DESIGN/DEVELOPMENT REVIEW COMMISSION
DESIGN REVIEW DISTRICT
HISTORIC AGENDA
EVALUATION SHEET
Case #6

ADDRESS: NX2221 Clark Street

NATURE OF REQUEST: Request for a Certificate of Design Approval for new construction

Right elevation (Staff recommendations)

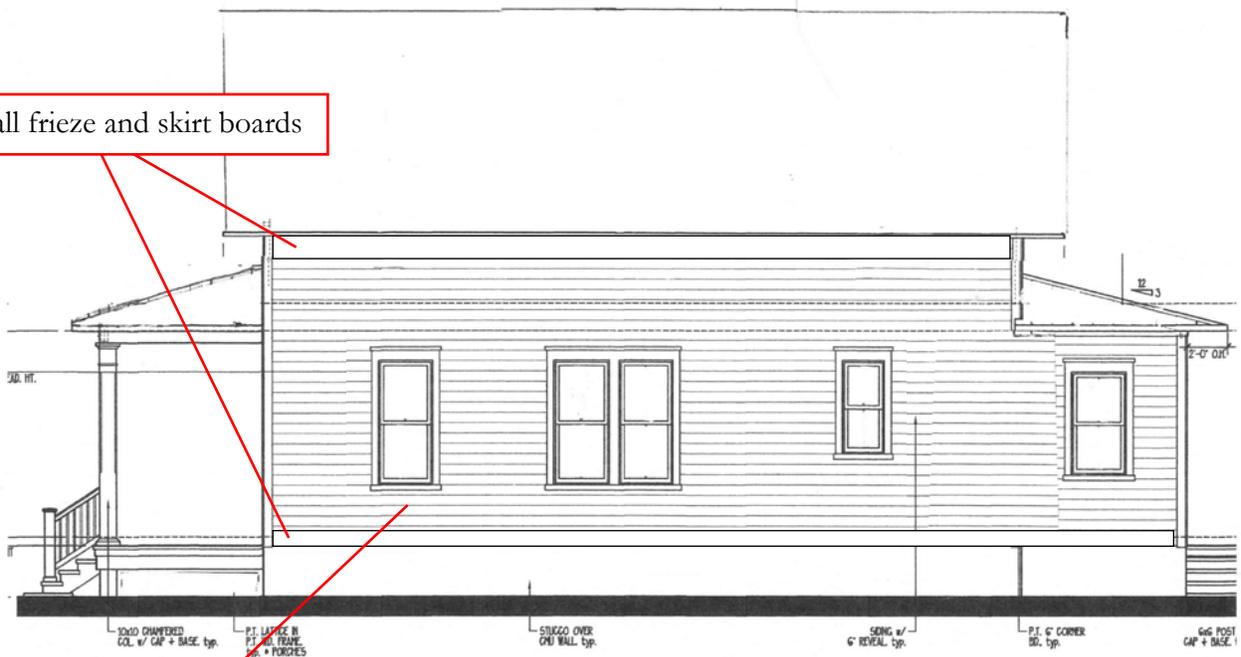
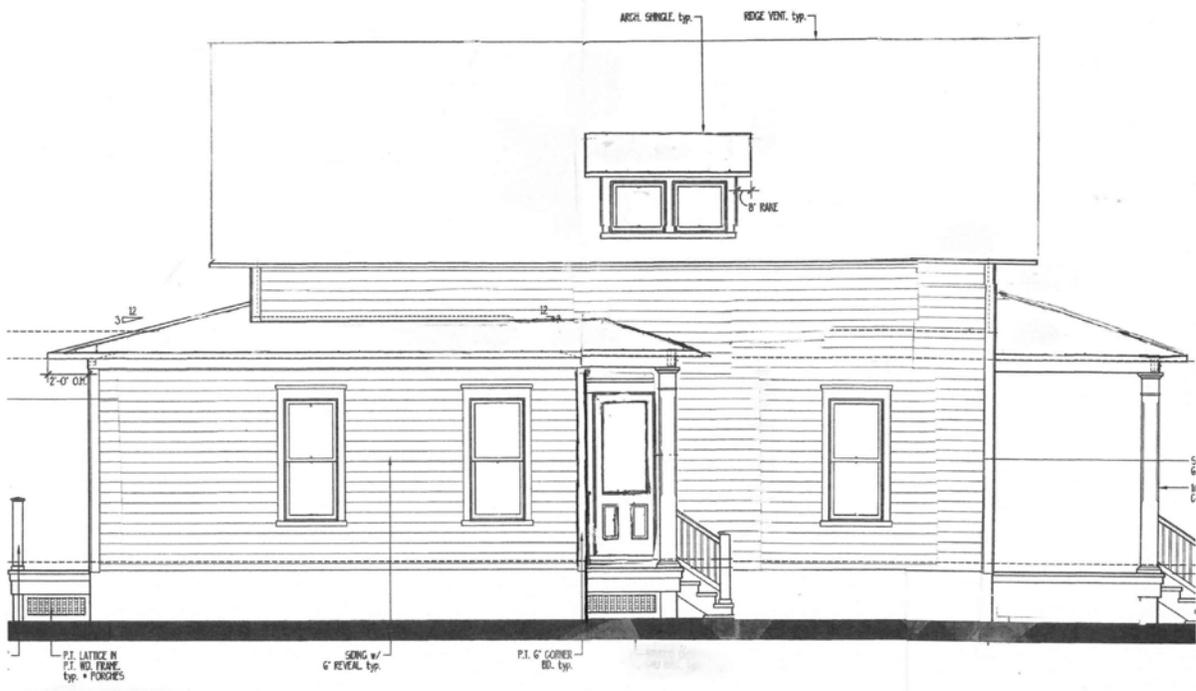
The massing of the proposed house is generally compatible with existing historic buildings on the block or street. The fenestration patterns on the façade and both side elevations are appropriate; however, the windows on the right elevation should be moved up or enlarged vertically to visually decrease the space between the window headers and the soffit. As proposed, this space is considerably more than what is typically found on historic 1½-story houses. A frieze board above the windows and a skirt board below the windows would effectively reduce the amount of visible siding. The left elevation has the same distance between the window headers and the soffit, but this space is somewhat disguised by the 1-story projecting portion on the rear of the house. Staff recommends adding the frieze and skirt boards to this side as well for consistency.

Install frieze and skirt boards

Move windows up to visually decrease the space between the headers and the frieze board
